March 8, 2012

**RE: Addendum to the FS Report
Penn Yan Former MGP Site
Village of Penn Yan, Yates County, New York
NYSDEC Site No. 8-62-009**

Revised Alternative S-2 Excavation/Dredging Of Visually Impacted Sediment

ALTERNATIVE S-2 - EXCAVATION/DREDGING OF VISUALLY IMPACTED SEDIMENT

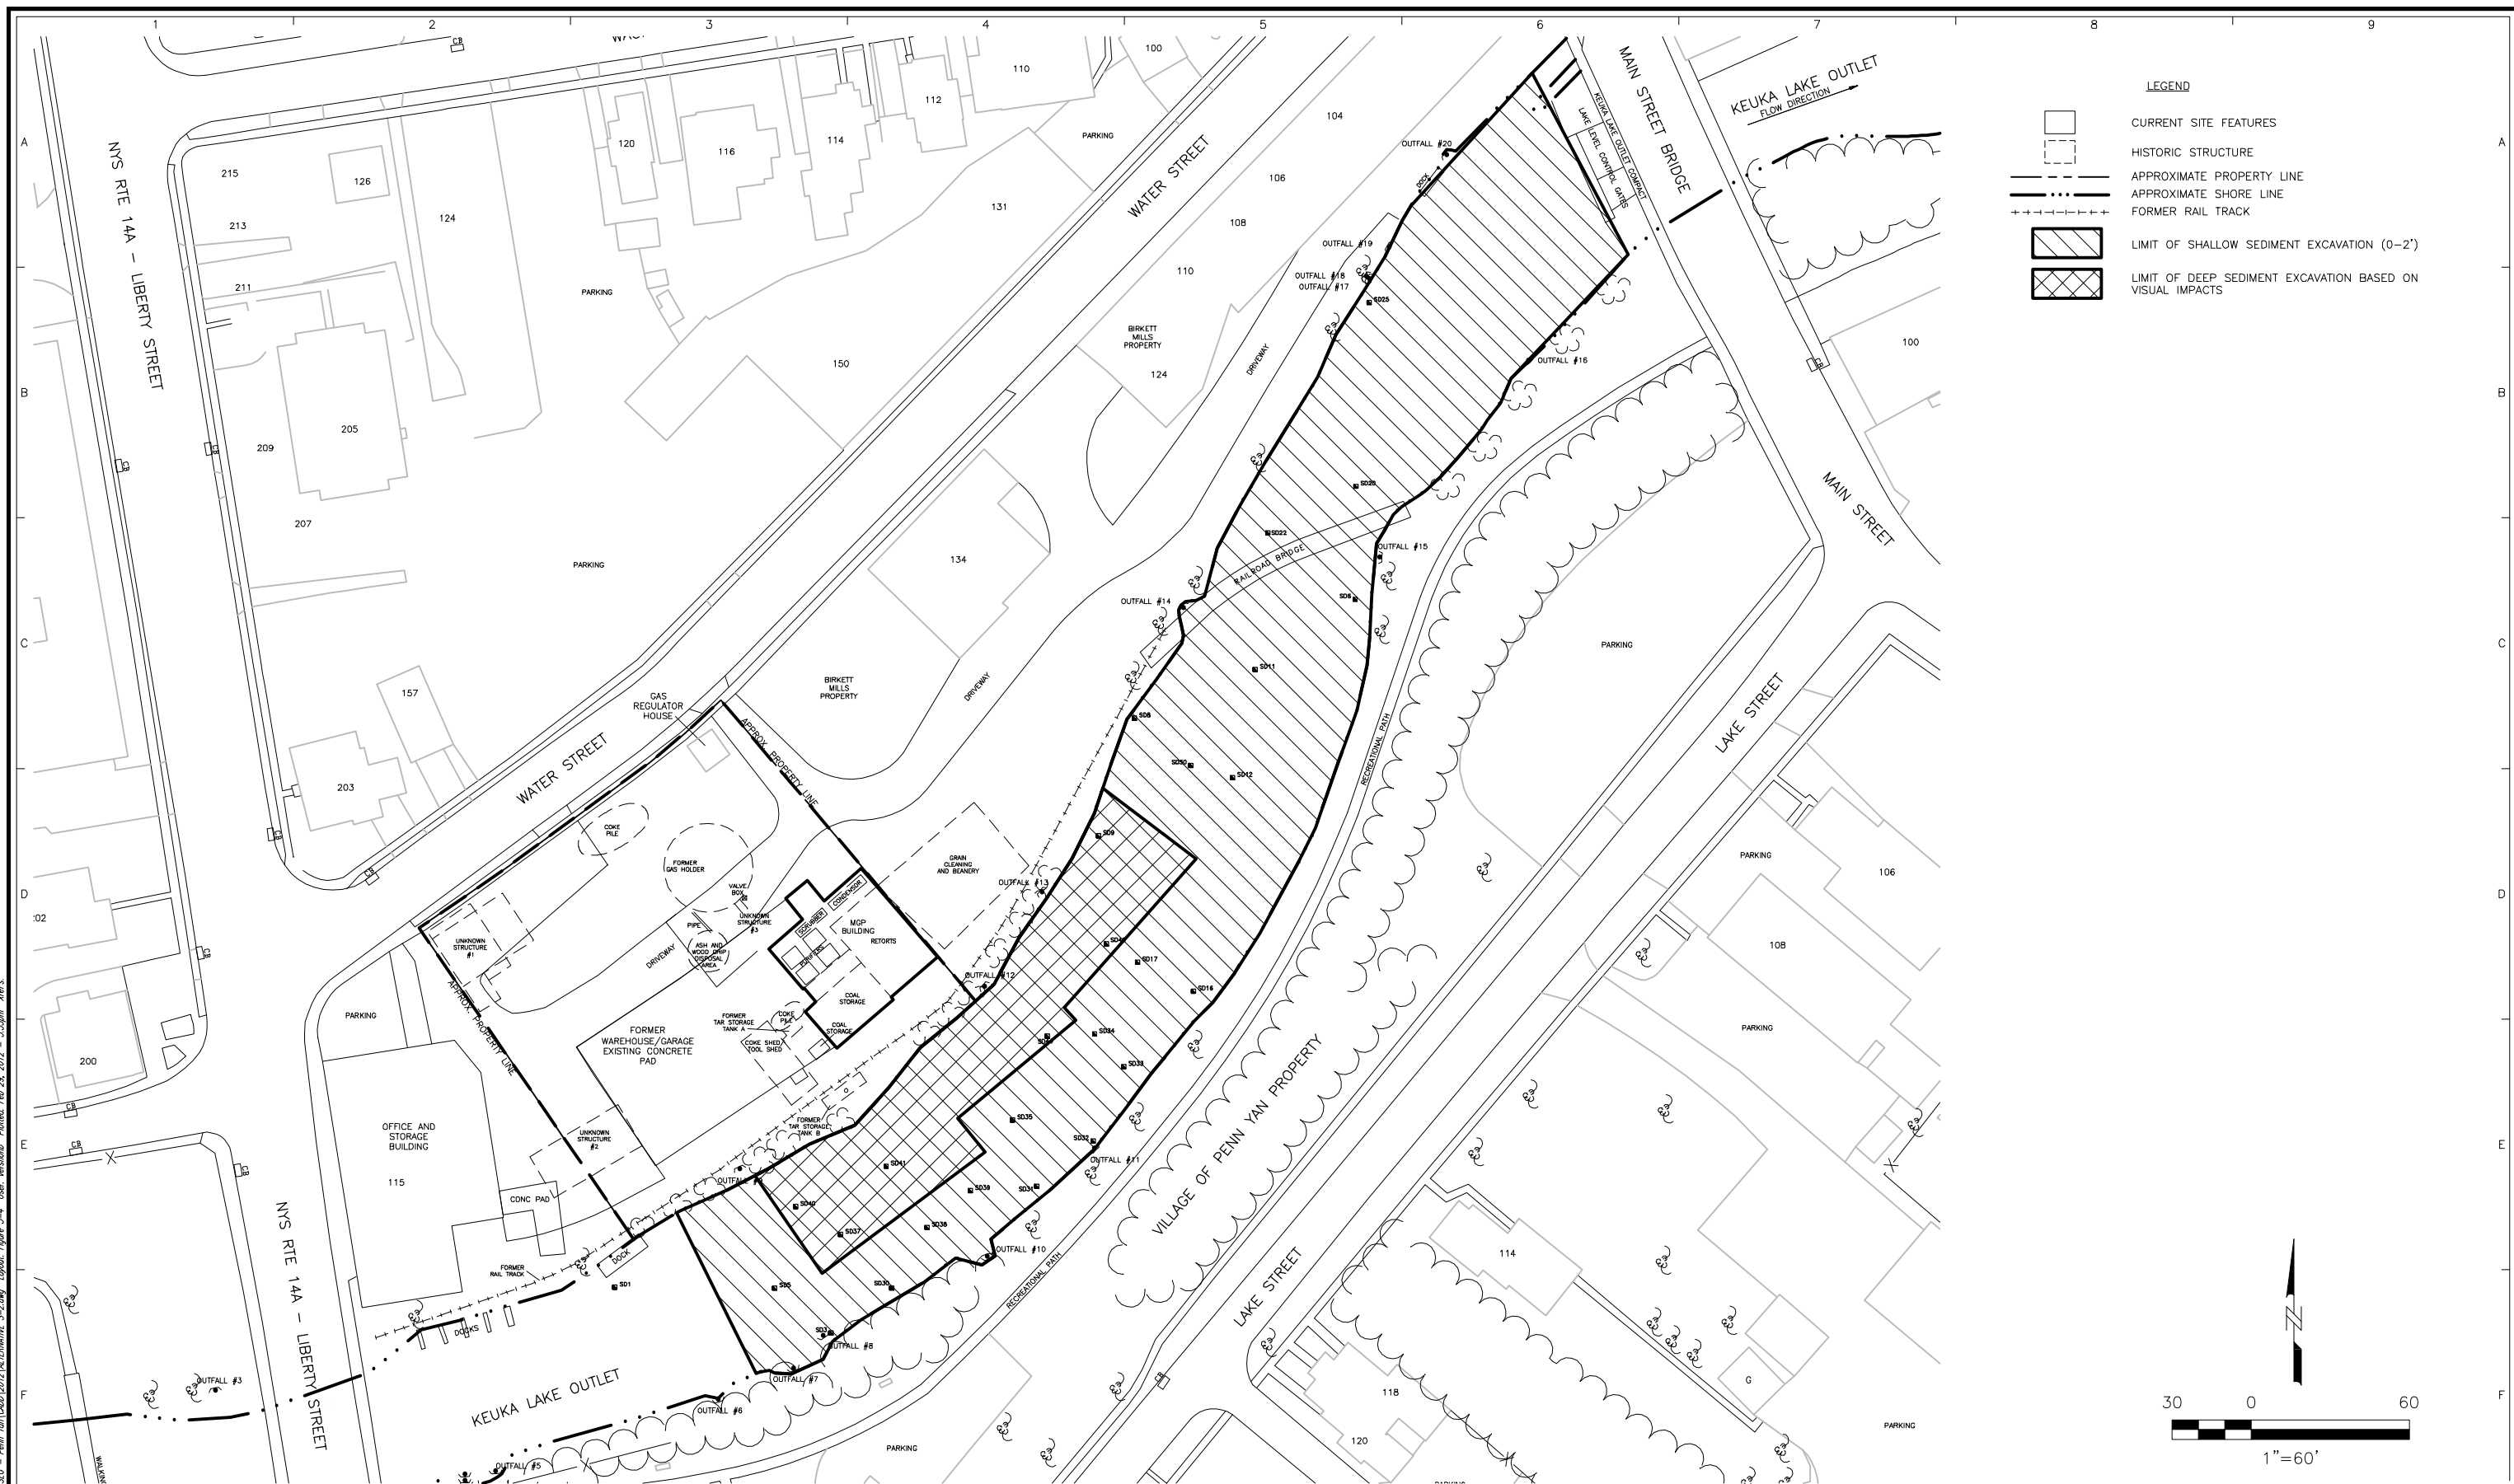
- NYSEG's recommended remedial alternative for the river portion of the site is Alternative S-2, Excavation/Dredging of Visually Impacted Sediment. This alternative, as described in the FS Report, includes excavation or dredging of the top one foot of sediment downstream to the lake level control gates at Main Street. NYSDEC has directed NYSEG to revise the alternative to require excavation or dredging of the top two feet of sediment, unless sediments do not exceed background concentrations. Attachment B provides revised Section 5.4.2, Table 5-8, and Figure 5-4 from the FS report describing NYSEG's proposed approach to addressing this issue. The text is provided in both redline/strikeout and standard format.

Figure 5-4 shows the layout of Alternative S-2. Design elements of the alternative include the following:

As part of Alternative S-2, sediment located within the identified limits of sediment impacts upstream of the outlet control structure will be excavated to remove sediment visually impacted by MGP materials. to a depth of at least one foot below the sediment surface. In areas where visual impacts extend deeper than one foot below the sediment surface, the sediments will be excavated until they are visually clean. No impacts have been identified in the clay layer underlying the site, so it appears to serve as a confining layer and will serve as a natural limit of vertical excavation. In areas where there are no visual impacts, sediment will be removed to a depth of no more than two feet below the sediment surface. The final required limits of excavation would be refined based on the results of a pre-design investigation (PDI). If the results of the PDI indicate that concentrations of total PAHs in sediment are less than the established sediment background value of 42.6 mg/kg, the required depth of sediment removal may be reduced. Excavation would be conducted using conventional earth moving equipment. Alternate methods of sediment removal, including mechanical or hydraulic dredging, may be considered during design.

Sediment would be transported to an onsite soil staging area staging for dewatering and/or blending of amendments to reduce soil moisture before leaving the site. Excavated materials would be transported to a permitted thermal treatment facility or landfill. Approximately 2,5405,080 cubic yards of sediment from the top two feet over an area of 68,500 square feet would be excavated. An additional 13,170 square feet of sediment would be excavated as deep as the underlying clay layer for an additional 2,0301,550 cubic yards of sediment. The total quantity of sediment to be excavated and sent off-site for treatment or disposal is estimated to be 8,46011,670 tons.

As part of Alternative S-2, sediment located within the identified limits of sediment impacts upstream of the outlet control structure will be excavated to remove sediment visually impacted by MGP materials. No impacts have been identified in the clay layer underlying the site, so it appears to serve as a confining layer and will serve as a natural limit of vertical excavation. In areas where there are no visual impacts, sediment will be removed to a depth of no more than two feet below the sediment surface. The final required limits of excavation would be refined based on the results of a pre-design investigation (PDI). If the results of the PDI indicate that concentrations of total PAHs in sediment are less than the established sediment background value of 42.6 mg/kg, the required depth of sediment removal may be reduced. Excavation would be conducted using conventional earth moving equipment. Alternate methods of sediment removal, including mechanical or hydraulic dredging, may be considered during design.

Sediment would be transported to an onsite soil staging area staging for dewatering and/or blending of amendments to reduce soil moisture before leaving the site. Excavated materials would be transported to a permitted thermal treatment facility or landfill. Approximately 5,080 cubic yards of sediment from the top two feet over an area of 68,500 square feet would be excavated. An additional 13,170 square feet of sediment would be excavated as deep as the underlying clay layer for an additional 1,550 cubic yards of sediment. The total quantity of sediment to be excavated and sent off-site for treatment or disposal is estimated to be 11,670 tons.
